2018 GROUP A PROPOSED CHANGES TO THE I-CODES COLUMBUS COMMITTEE ACTION HEARINGS

April 15–23, 2018
Columbus Convention Center
Columbus, Ohio

Publication Date: February 2018

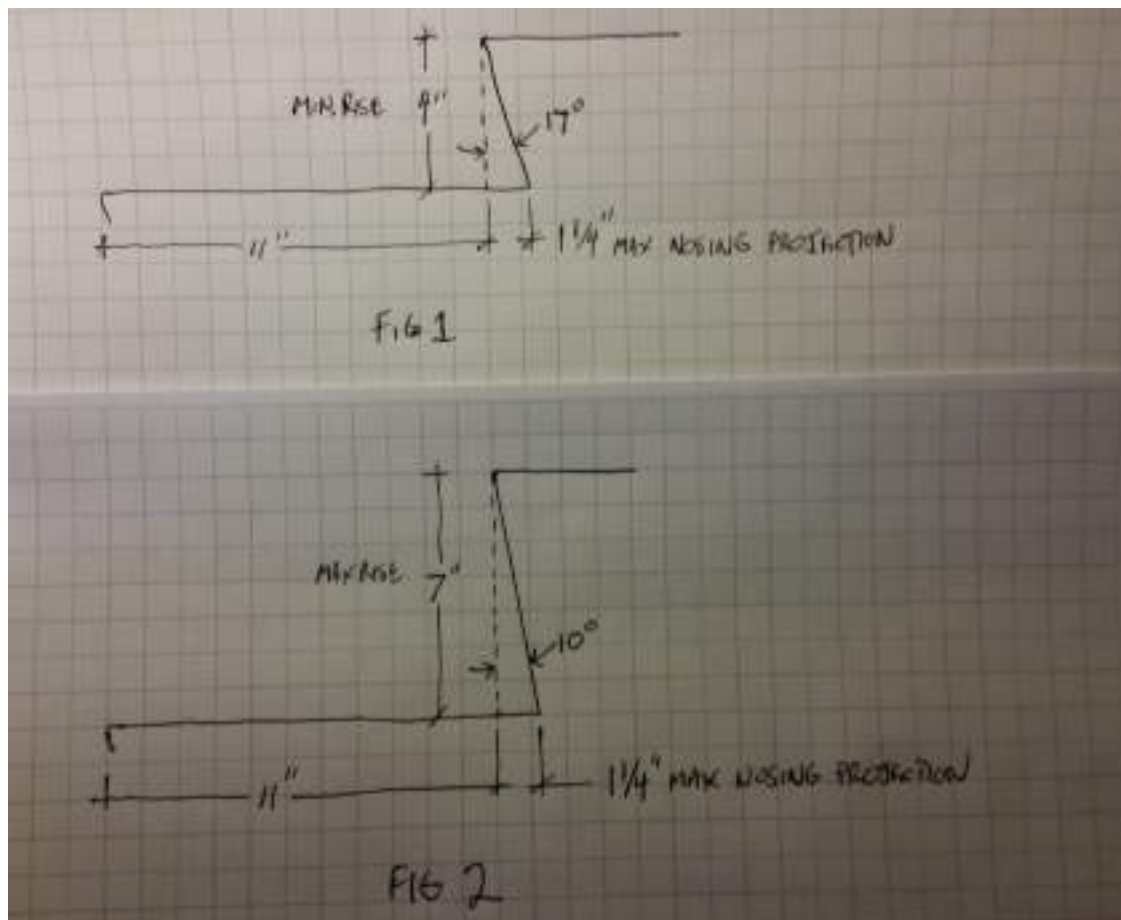
Figure 1 illustrates the sloped riser angle at the minimum riser height and maximum nosing projection. Figure 2 illustrates the sloped riser angle at the maximum riser height and maximum nosing projection. The current language is confusing because it is impossible to slope the riser anywhere close to 30 degrees without greatly exceeding the maximum nosing projection. The proposed change correlates an appropriate limit and clarifies widely misunderstood code language.

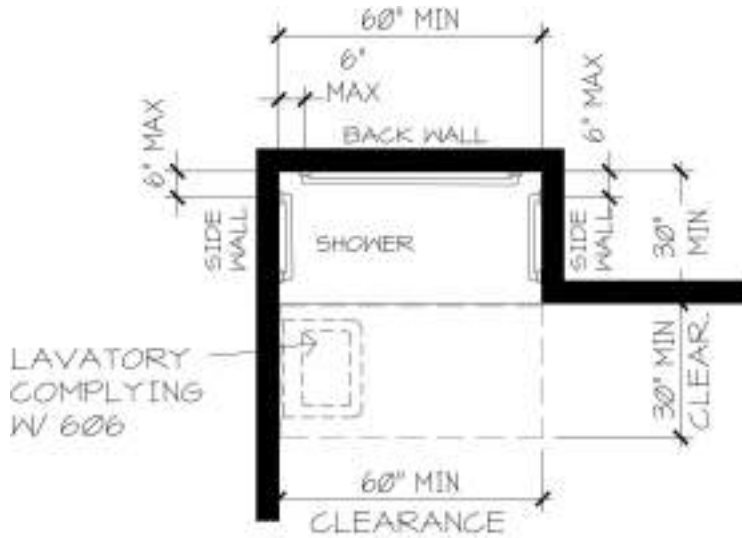
The key part of this change is to remove the requirement for permanently installed folding or fixed seats. These wall-mounted seats do not work well when residents are being assisted with showering. The wall mounted seats make it challenging for care-givers to access the back and one side of the resident they are bathing. Most often, if residents cannot stand for bathing, a portable, rolling chair is used and the folding seat stays folded up (but takes up space). This allows the care-giver greater access to all sides of the resident. In addition, the rolling chair is often easier to transfer to for older adults, than a wall mounted seat.

This proposal also recognizes alternate shower configurations that provide equal, if not better accessibility. For example, many nursing homes provide a "European" shower where two sides are open to the bathroom. This provides greater access for both resident with mobility issues as well as the care-giver. Water can be managed with shower curtains, either on a curtain track or an "L-shaped" curtain rod, however usually the entire room is designed to be a "wet room".

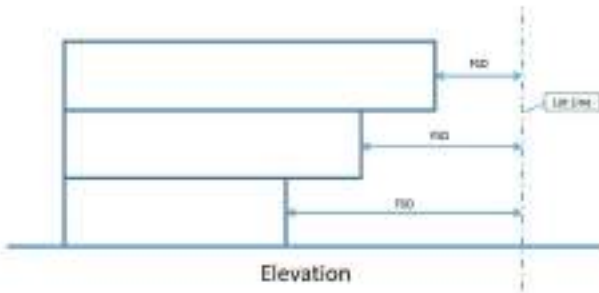
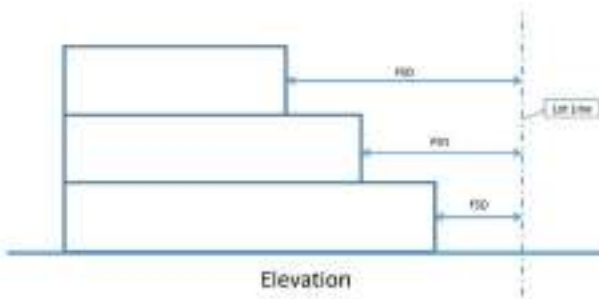
The definition of fire separation distance in Section 202 is a measurement from the building face and is a method of measurement to a reference point whether a lot line or an imaginary line. It stands to reason that if the code intent is for a lot line or imaginary line to be vertical that there should be one line used for measurement purposes. When the term is used the code intends it to be used as a measurement to the same reference so the code change is not necessary. The code change however has a negative consequence and reduces fire protection without technical justification. Additionally the definition add in PS 11 may lead to the portion of the upper story projecting beyond the lower smaller story a projection.

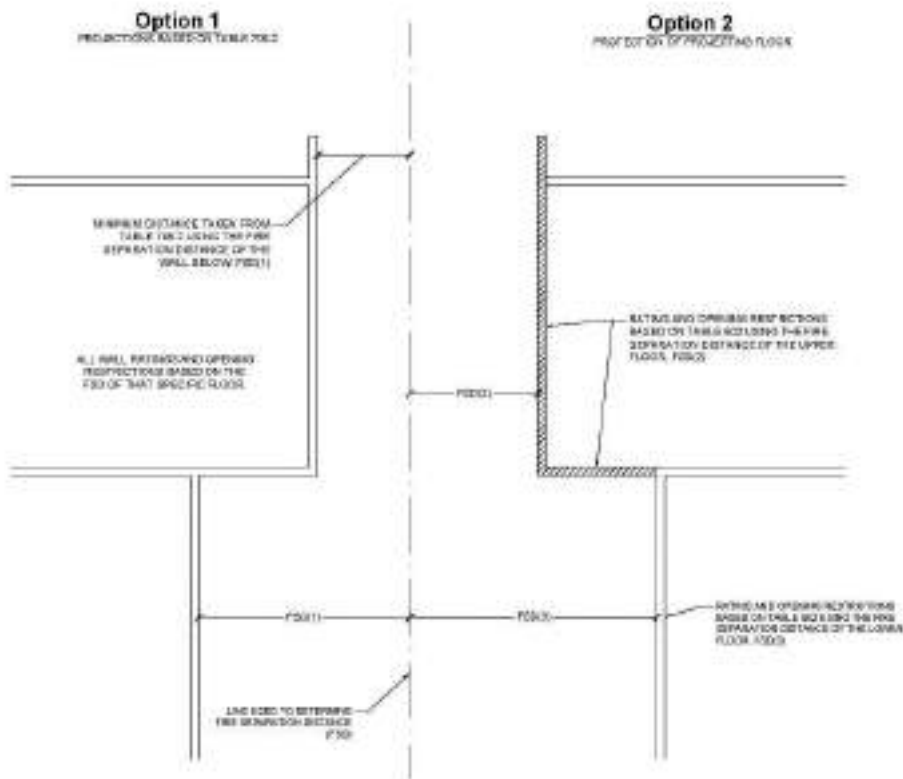
705.2.4 Projecting floors. Where the fire separation distance on a lower floor is greater than the fire separation distance on the floor immediately above, the projecting floor shall have the same fire-resistance rating as the exterior wall above based on Table 602. The fire-resistant rating of the horizontal portion shall be continuous to the lower vertical wall.

Example of less than 180 termination

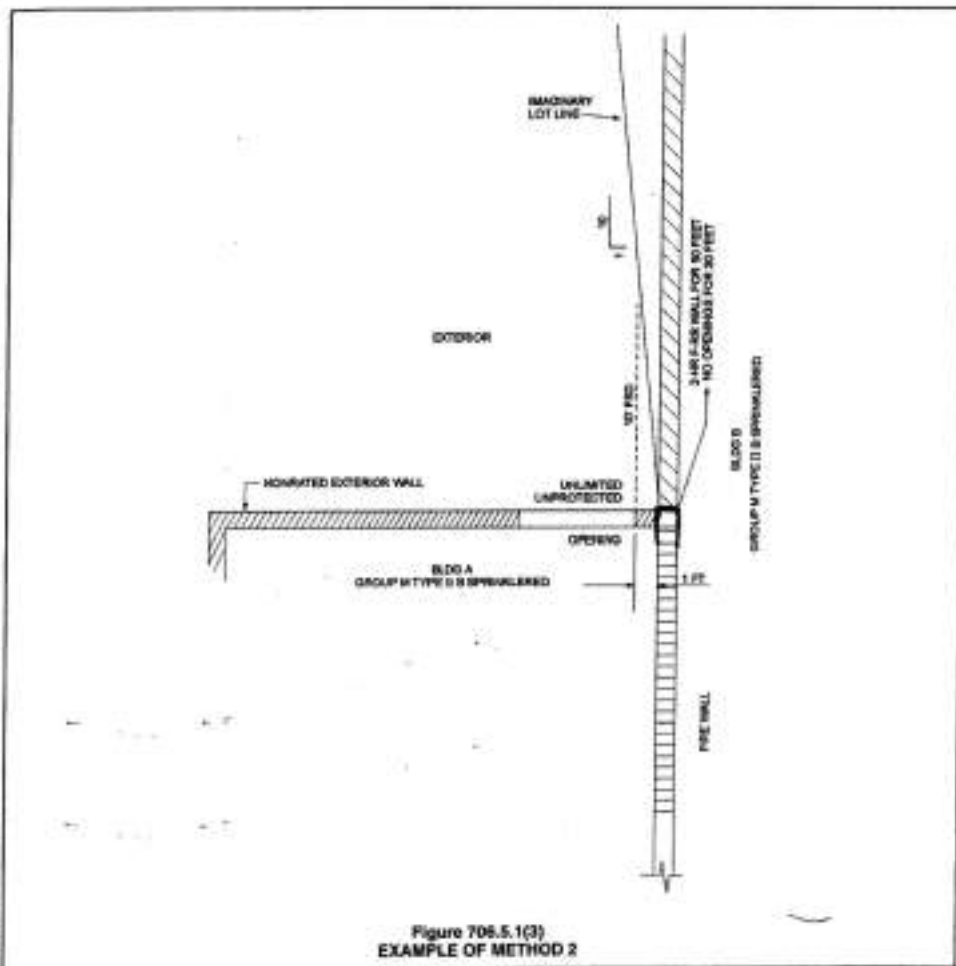
Section 706.5.2 addresses the firewall termination where the exterior walls on either side are at an angle less than 180 degrees. The first exception was removed because it makes no sense to allow this method when it would not be allowed if the buildings were separated by an inch. If two adjacent buildings are separated and joined by a fire wall and they have exterior walls that are exposed to each other at angles less than 180 degrees they should be treated as separate buildings for exposure purposes just as any two separate buildings would be treated. Current exception 1 gives you a less restrictive method when the building are touching; that makes no sense. The imaginary line exception is now a single requirement. The section was also cleaned up so it is clear how to apply the imaginary line. The current text literally states that the wall itself will assume to have an imaginary line. Walls cannot assume things. The current text also does not clearly state that the imaginary line is to be used to establish fire separation distances. Since that is not provided based on current text there is no protection requirement because section 705.5 and 705.8 are based on fire separation distance defined in chapter 2.

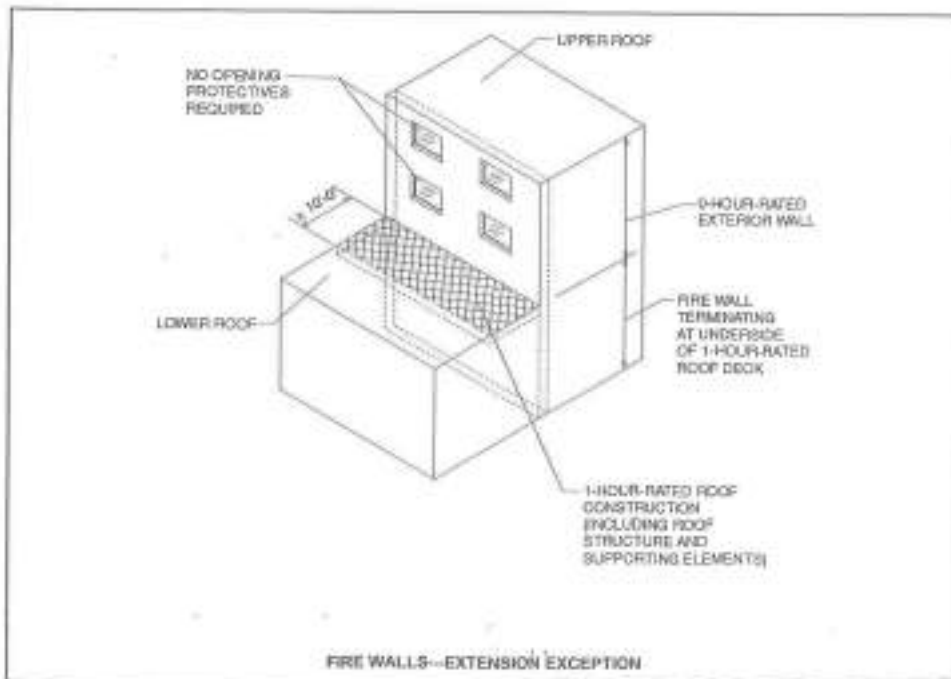
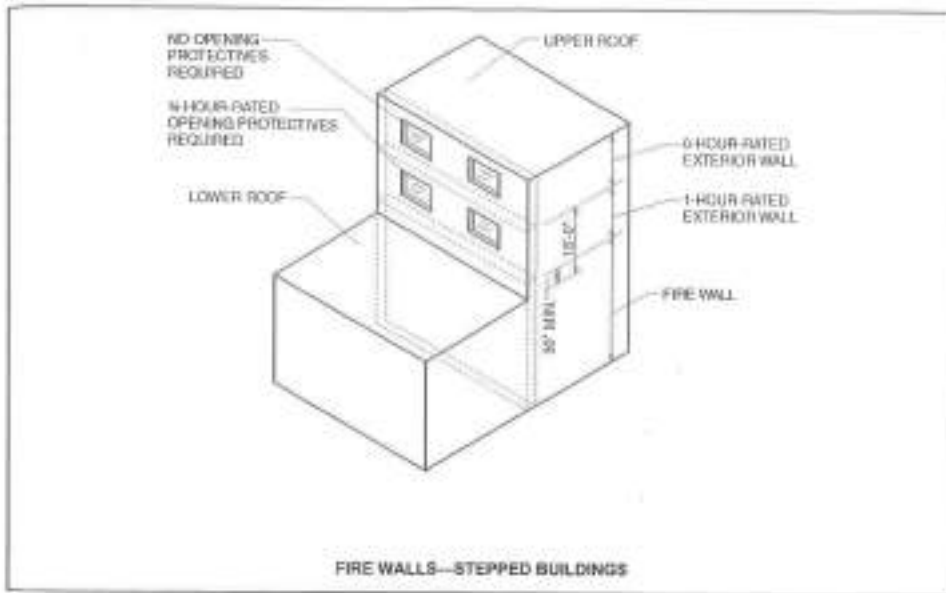
Section 706.6.1 is confusing as currently written. It is intended to regulate the design of fire walls and exterior walls above and in-line with the fire walls for buildings having stepped roof levels. The intent of this section is to maintain adequate separation between the two portions of the same building so that one side will not be damaged for the time required by Section 706.4. This is done by extending the fire wall to at least 30" above the lower roof and rating the exterior wall above and in-line to not less than 1-hour up to 15' above the lower roof. The second option is to provide a 1-hour rated roof assembly extending not less than 10' over from the fire wall with no openings permitted within the 10' portion of the roof adjacent to the fire wall.

This proposal does not change the requirements of the section. Rather, the text has been re-written to clarify the expectations for the exterior wall located above the lower roof and sets clear expectations in the exception for horizontal protection by itemizing these requirements.

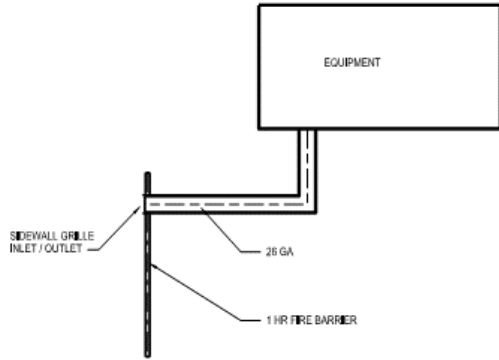
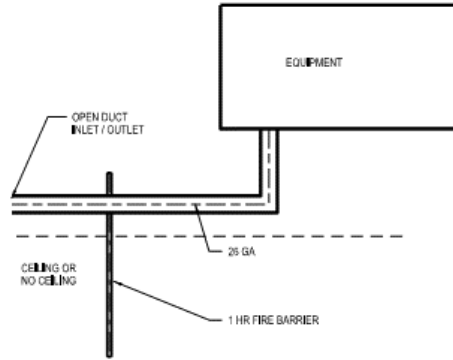
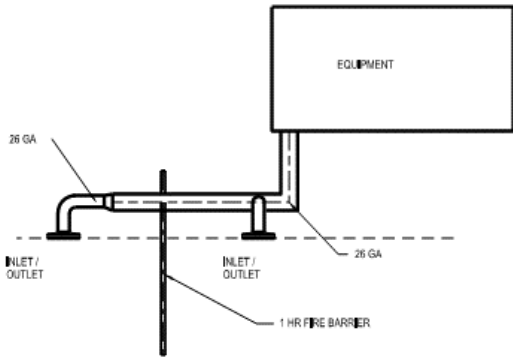
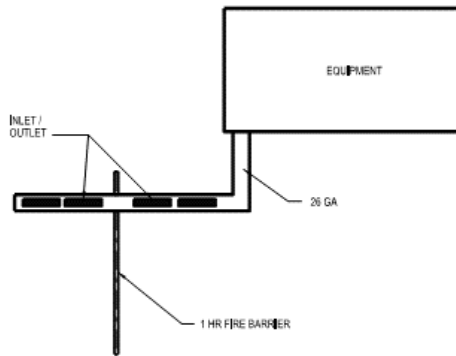
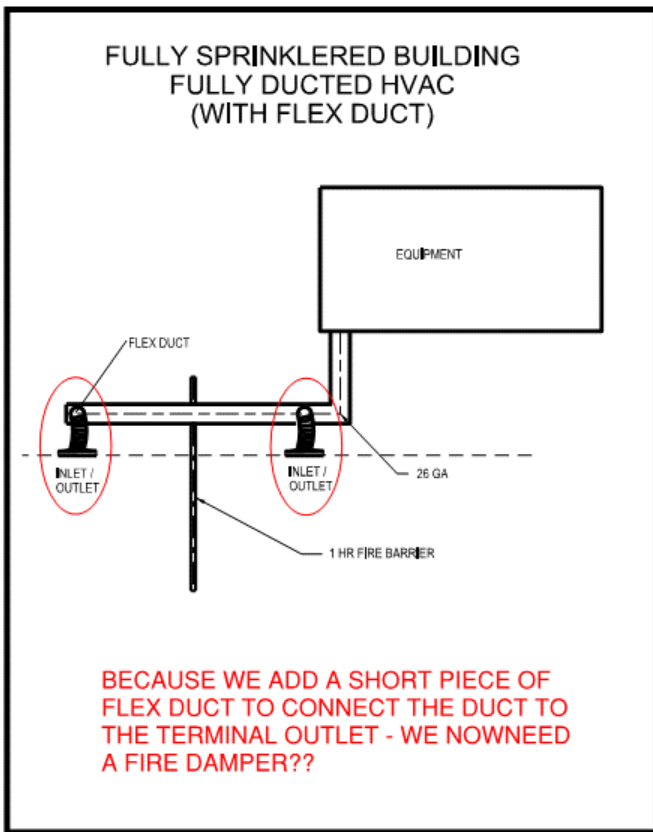
- 3.2. Non-metal flex connections shall be permitted from an overhead metal duct to a ceiling diffuser within the same room in accordance with Section 603.6.2 of the International Mechanical Code.

Likewise, a flex connection at the AHU within the mechanical space does not constitute a hazard that should trigger the fire damper within the system

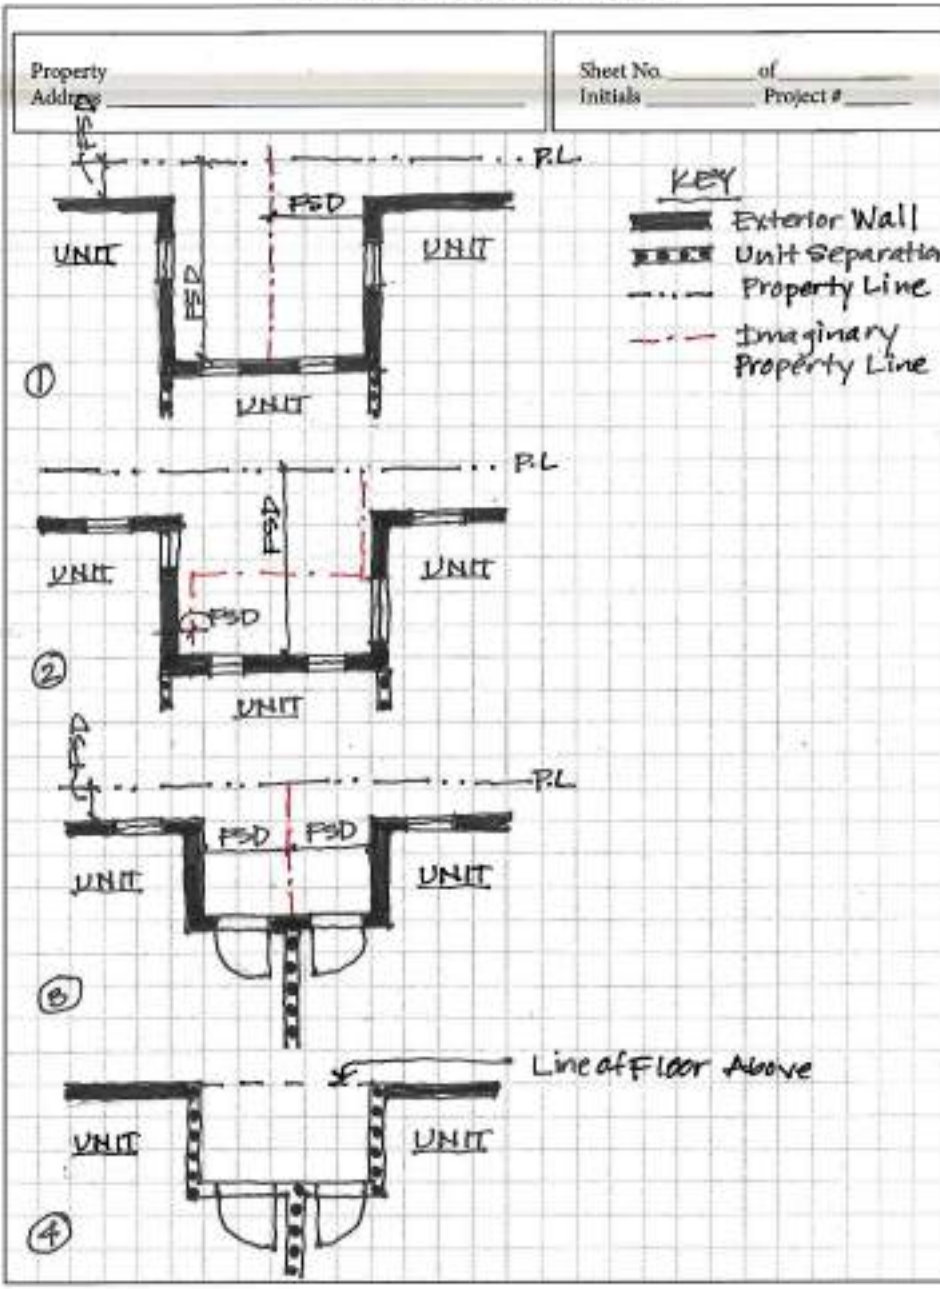
The code requires fire-rated construction between dwelling units, but does not specifically address the situation where the separating wall is exterior. The provisions of 705.3 establish a means to determine the required fire rating and allowable openings for exterior walls of two buildings on the same lot. The same principles should be applied to the requirements for dwelling unit separation.

Dwelling unit separation is intended to prevent a fire in one unit from spreading to other units in a building. If adjacent units have unprotected openings in close proximity, fire can more readily spread between units, and to exterior balconies, cladding and roof.

3114.8.5.3(1)
Bracing Unit Distribution--Maximum Linear Length

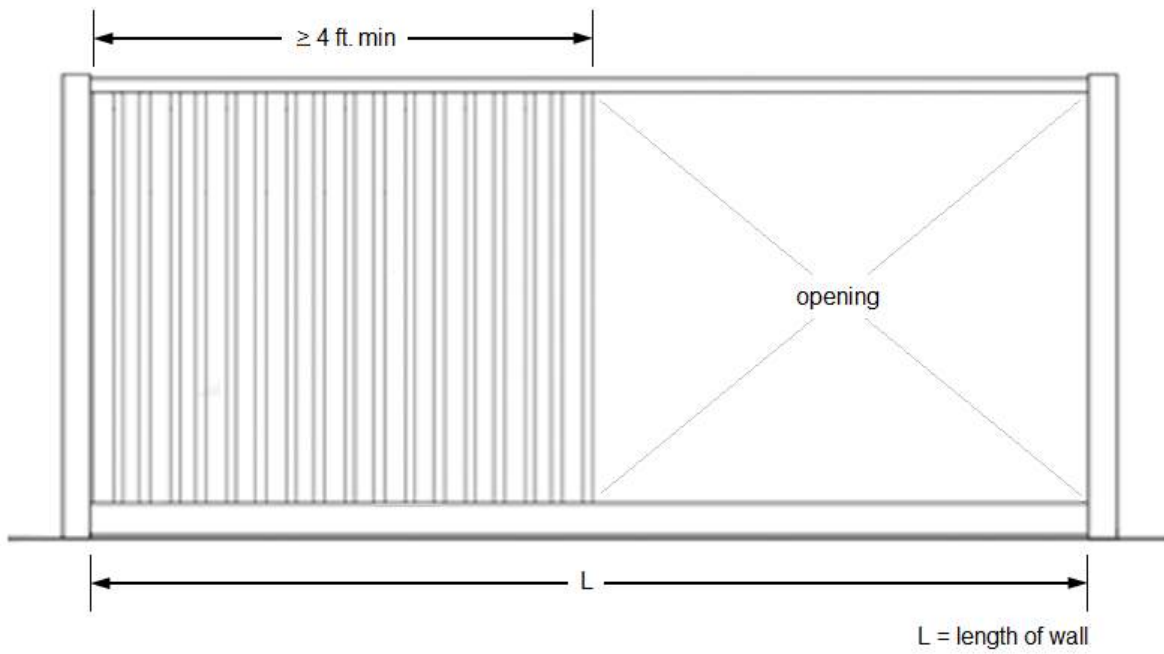
1. The total linear length of all openings in any individual side walls or end walls shall be limited to not more than 50% of the length of that side walls or end walls, as shown in Figure 3114.8.5.3(1).

3114.8.5.3(2)
Bracing Unit Distribution -- Minimum Linear Length

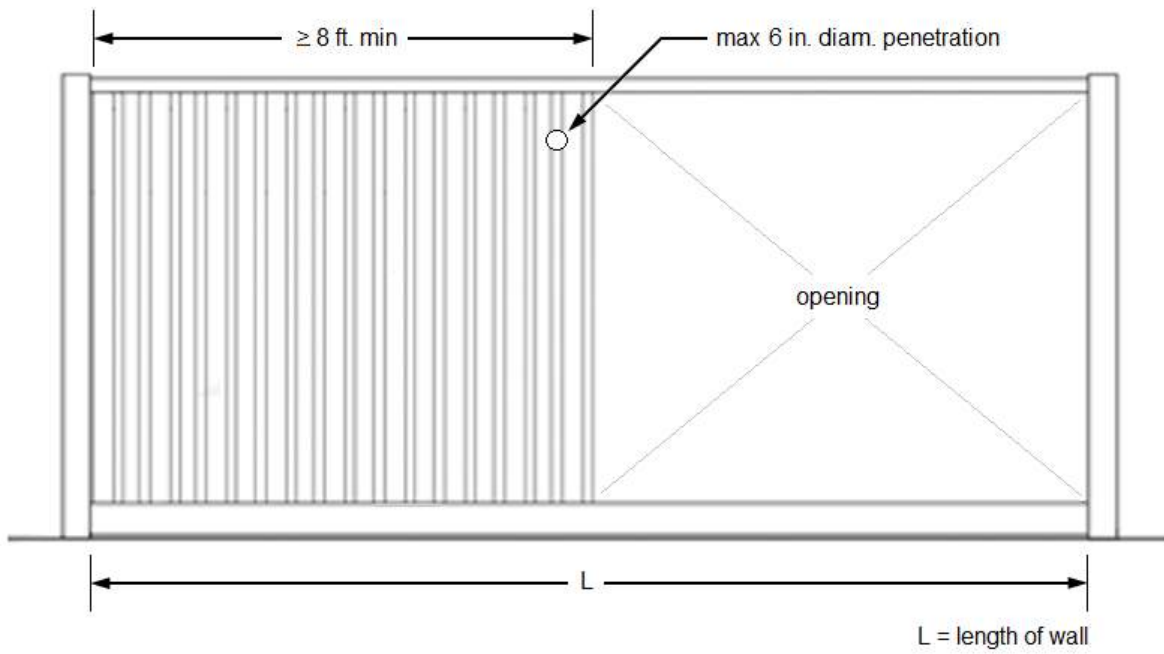
2. Any full height wall length, or portion thereof, less than 4 feet (305 mm) long shall not be considered as a portion of the lateral force-resisting system, as shown in Figure 3114.8.5.3(2).
